Form 3160-5
(June 2015)

SUNDRY NOTICES AND REPORTS ON WELLS
Do not use this form for proposals to drill or to re-enter an abandoned well. Use form 3160-3 (APD) for such proposals.

8. Well Name and No.
BISTI COAL 12 1

DJR Operating LLC requests permission to Plug & Abandon the subject well per the attached Procedure, Current & Proposed Wellbore Diagram and Reclamation Plan.

**DJR Operating, LLC
Proposed Wellbore Diagram**

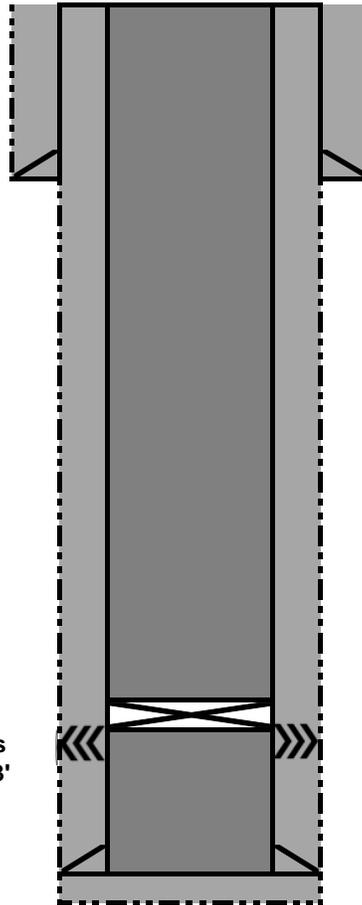
- BLM geologist's formation top picks vary from operator's, but the proposed P&A plan has cement from the retainer @ 1100' – Surface, so no changes are necessary.
- Log analysis of reference well #2 indicates the Nacimiento and Ojo Alamo sands investigated likely contain fresh water ($\leq 5,000$ ppm TDS). The submitted plugging plan has cement from the CR @ 1100' – Surface, which is adequate to protect freshwater sands in this well bore.
